CITY OF ALBUQUERQUE

Re: Juan Tabo Business Park
10901 Juan Tabo Pl. NE
Conceptual Traffic Circulation Layout for DFT Approval
Engineer's Stamp 08-16-23 (G21-D021)

DRAINAGE AND TRANSPORTATION INFORMATION SHEET

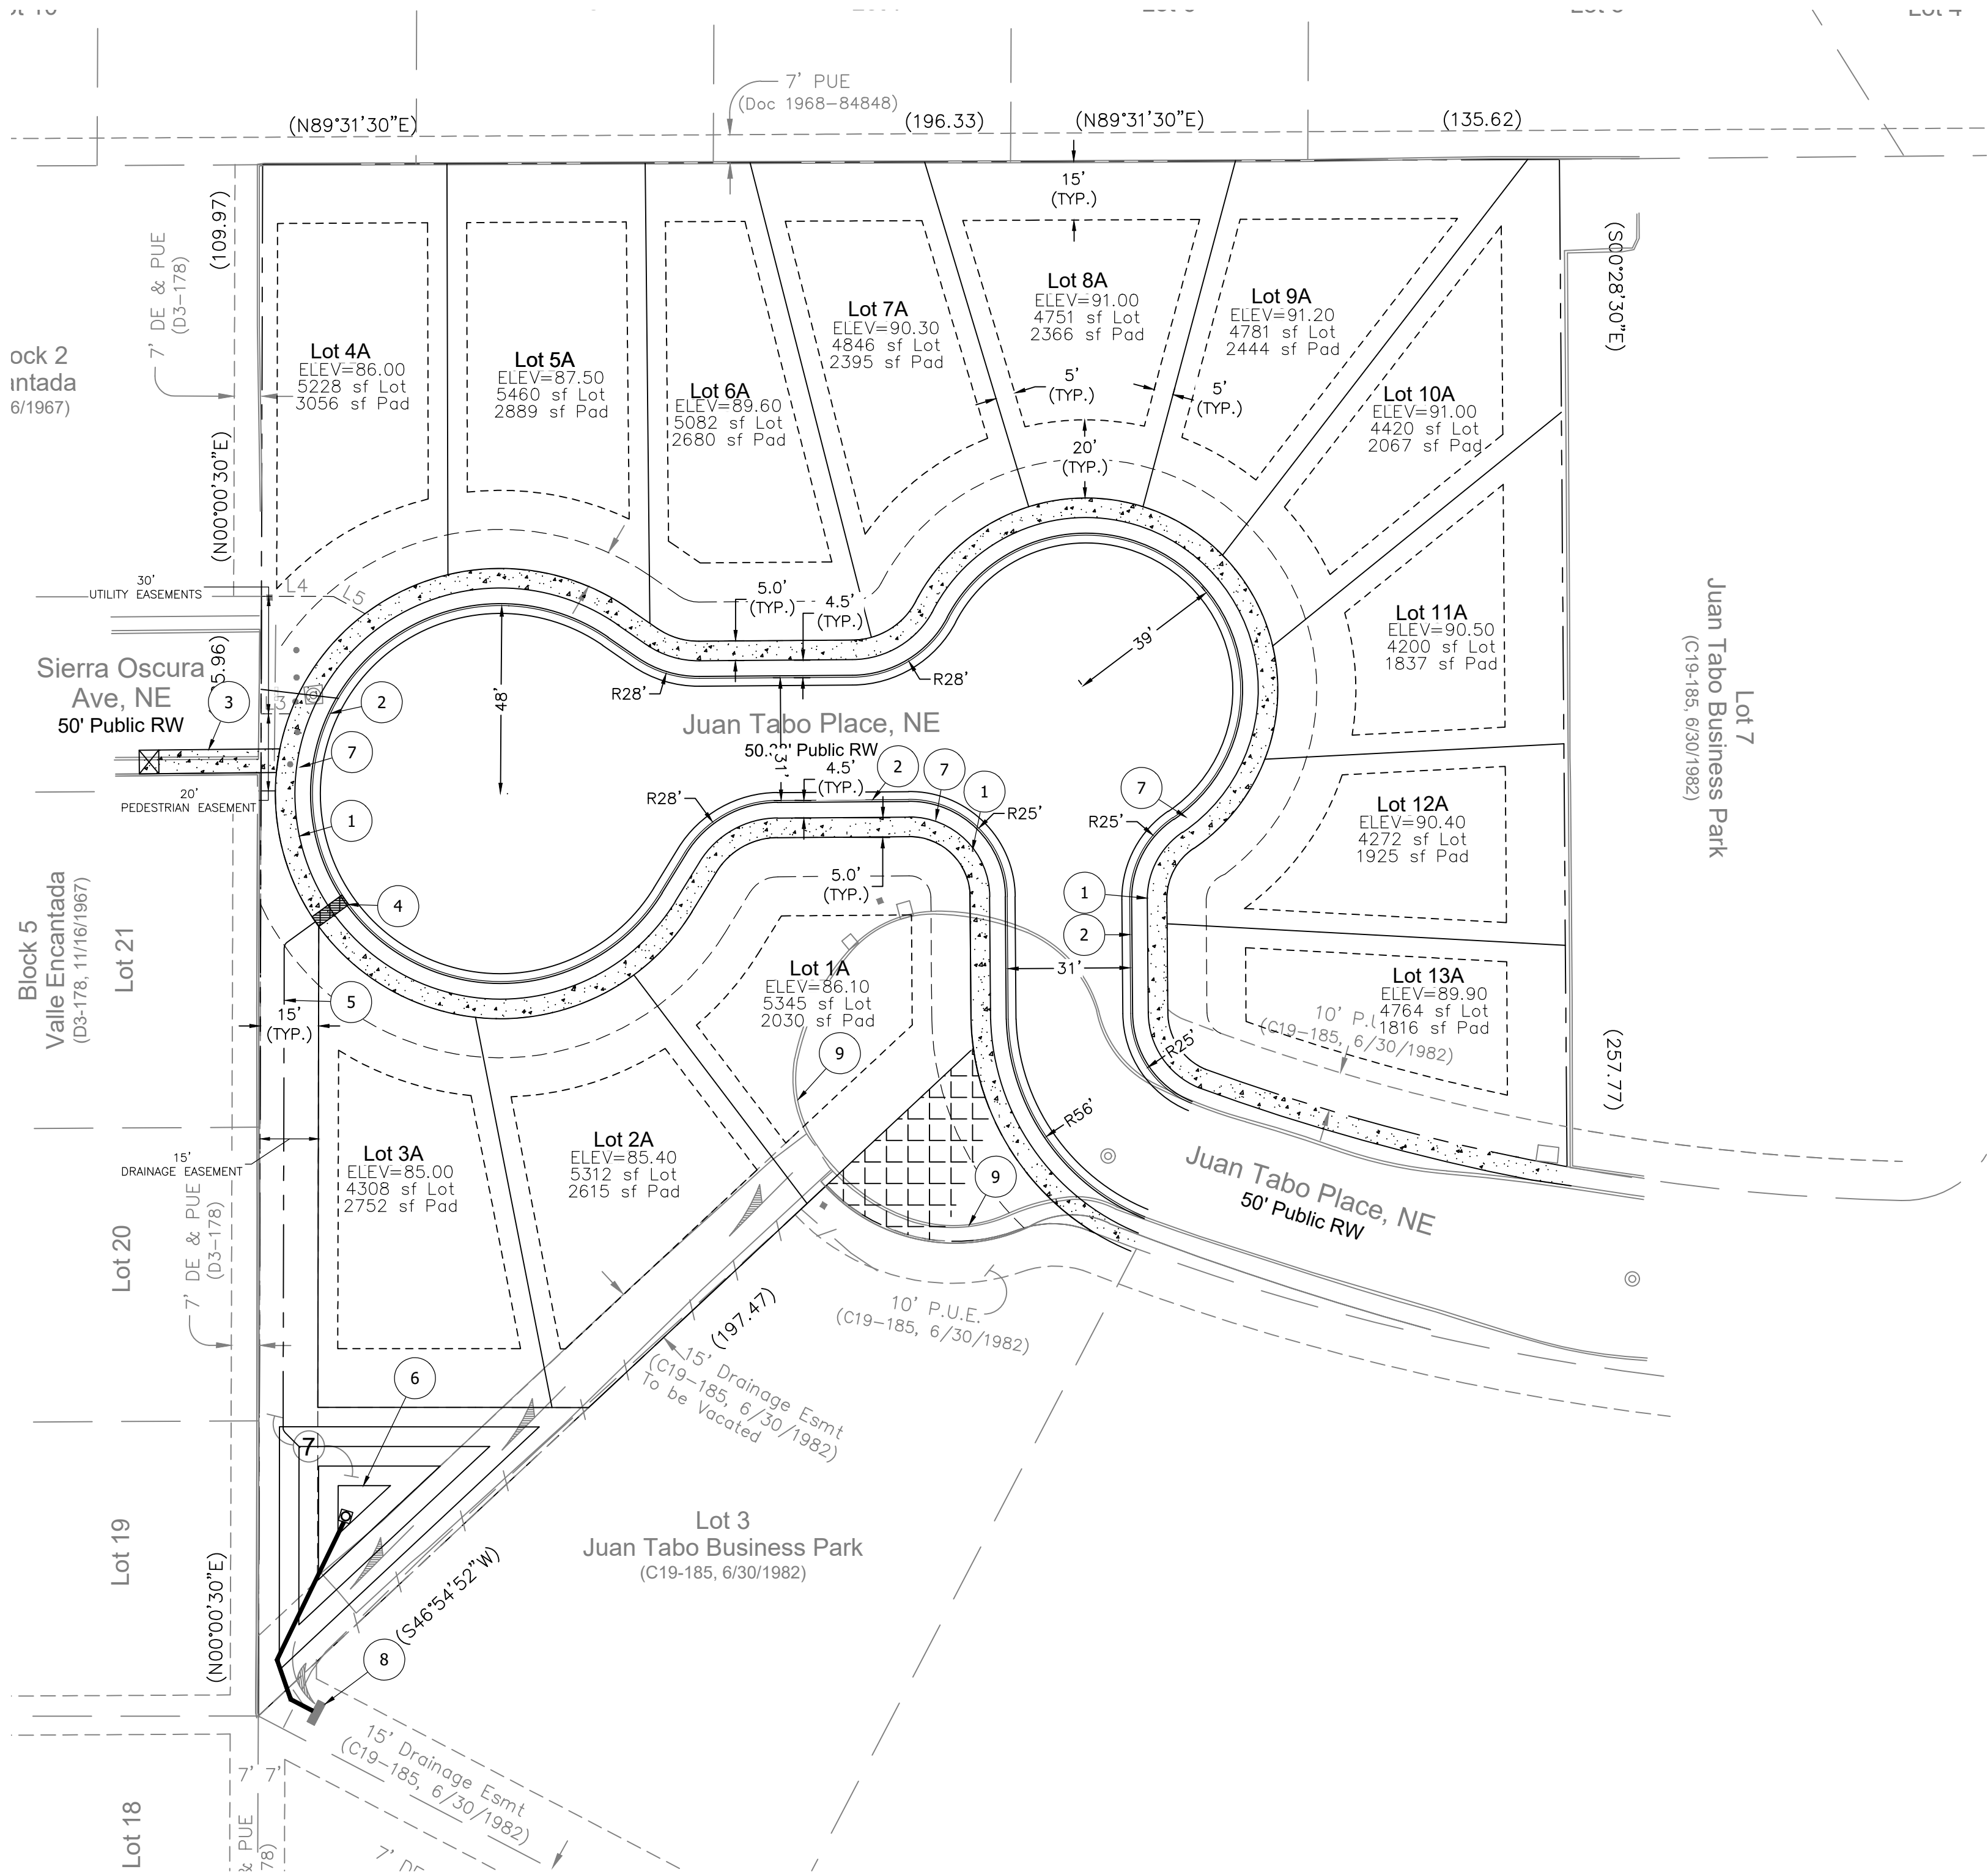
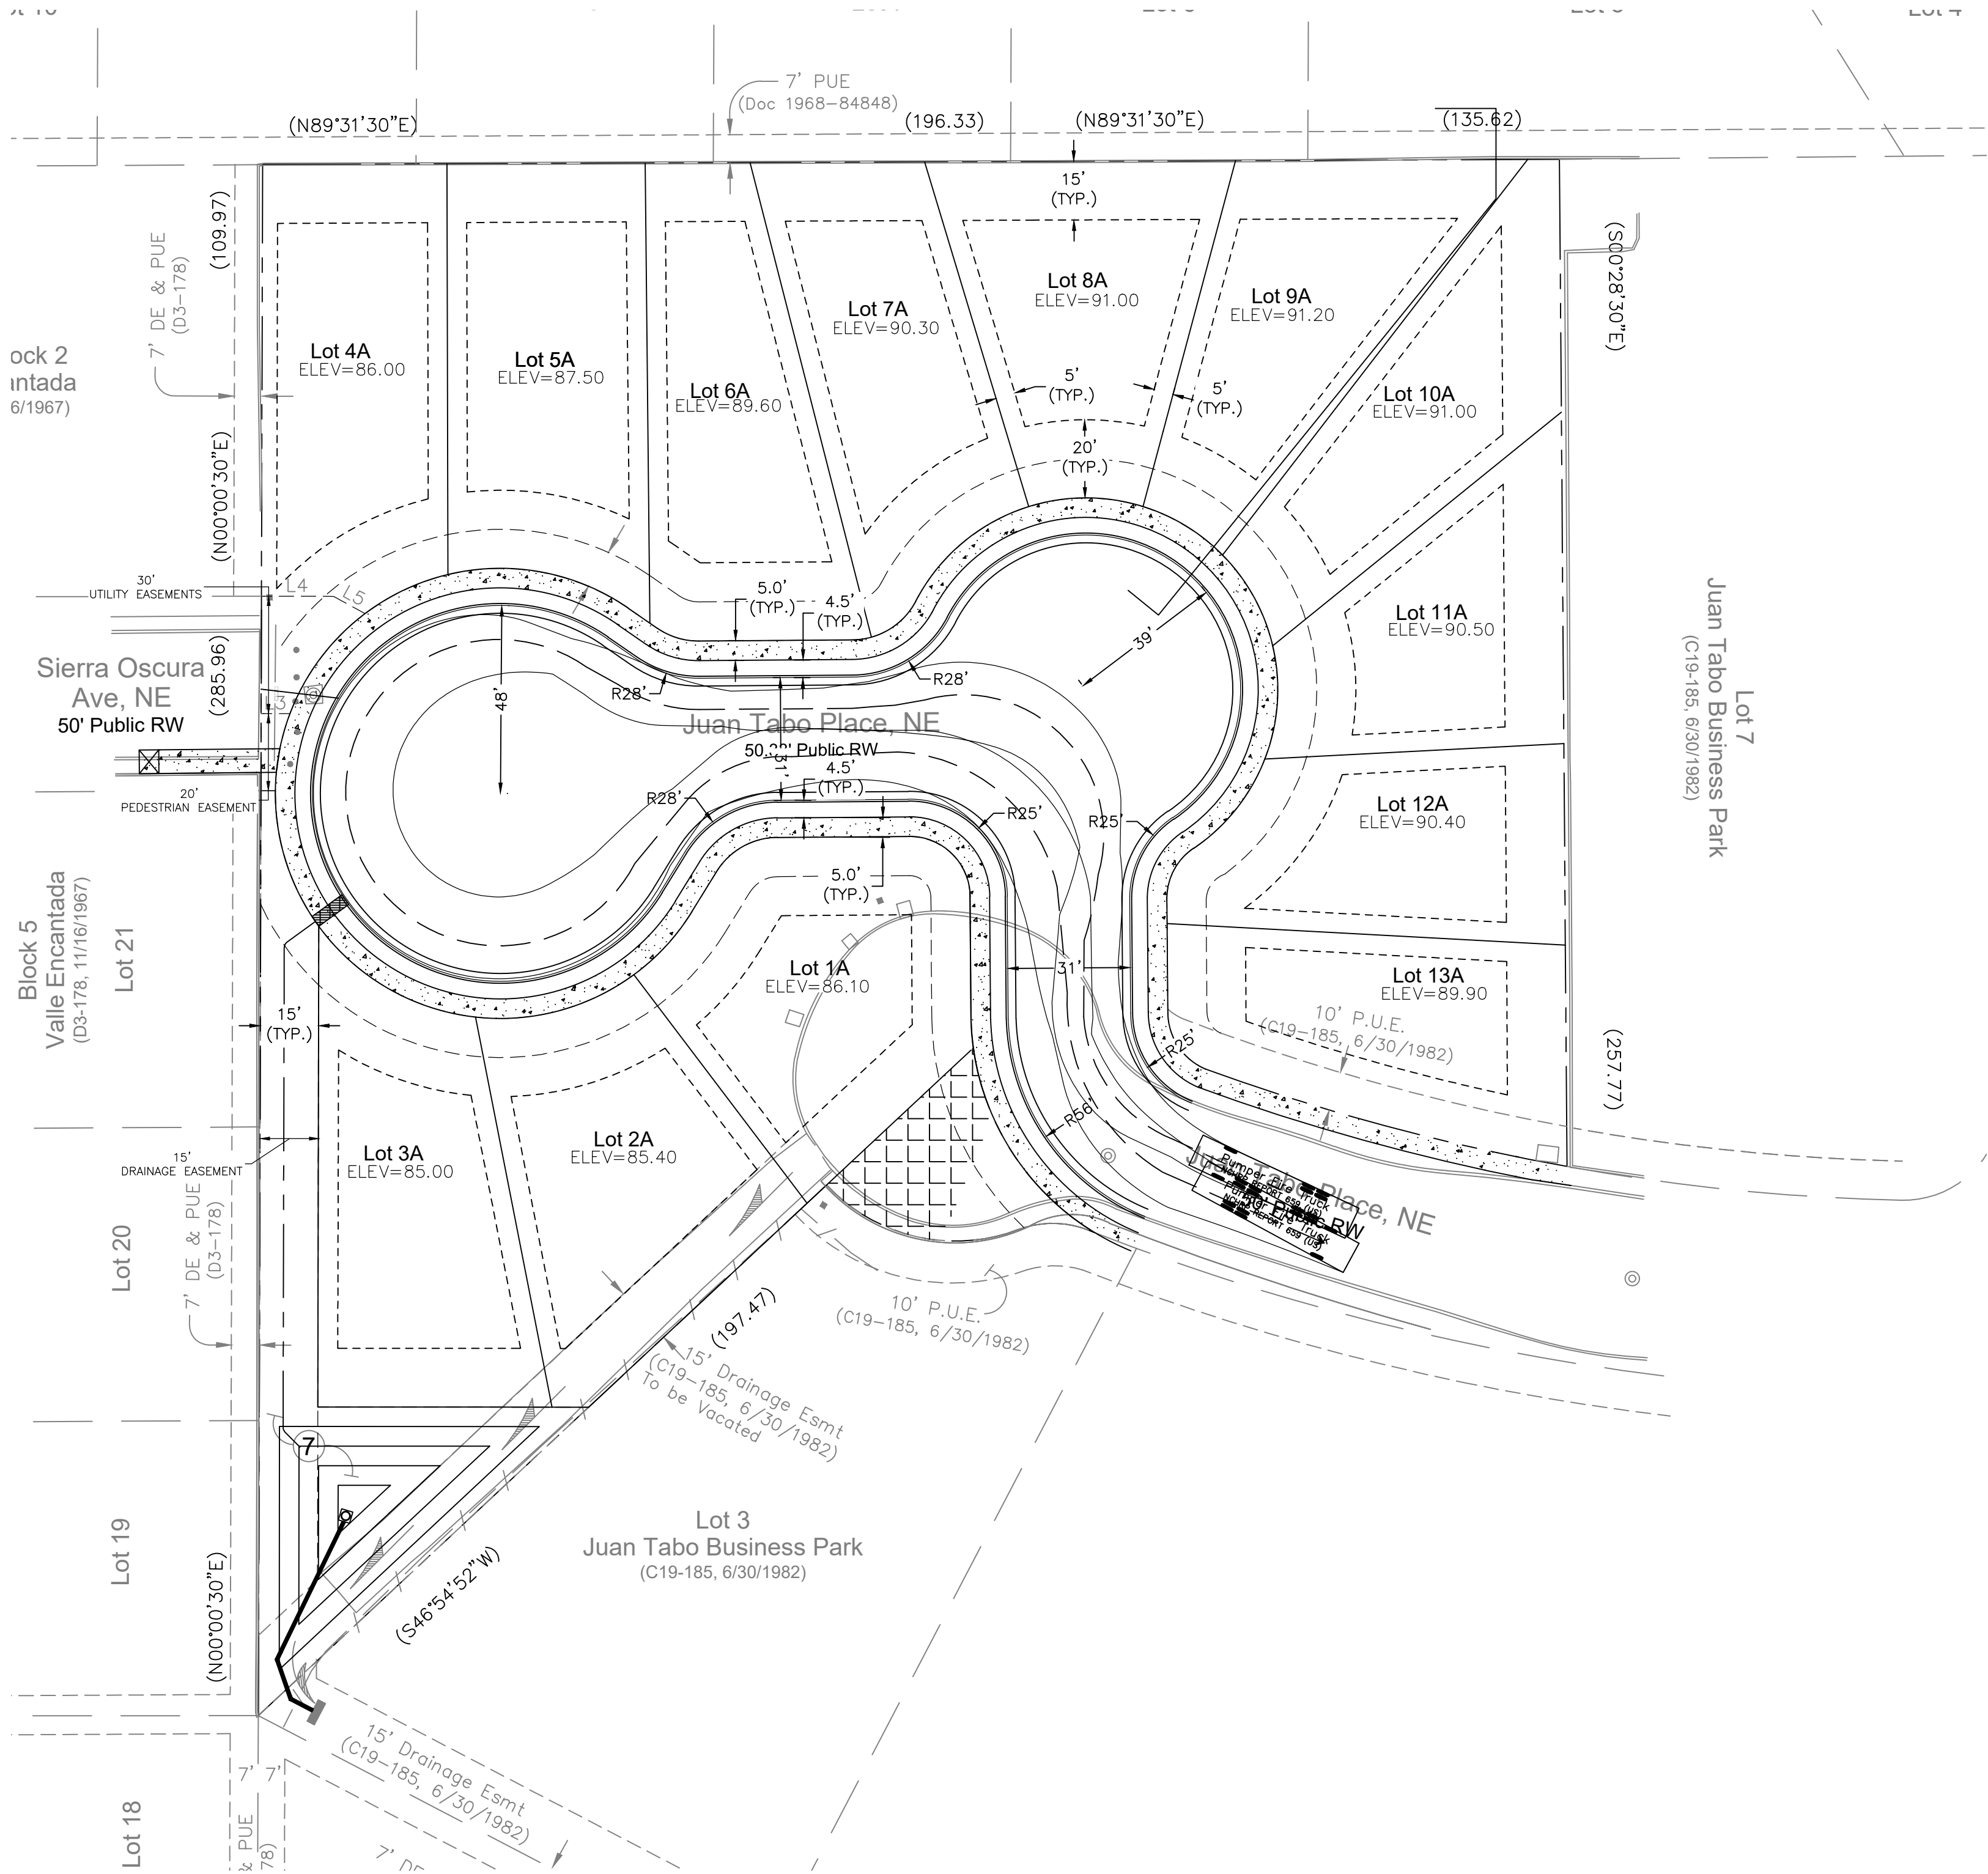
The conceptual TCL submittal received 08-18-2023 is approved for DHO and/or DFT submittal. When submitting this project through the building permit process, a full Traffic Circulation Layout will need to be submitted and approved prior to building permit.
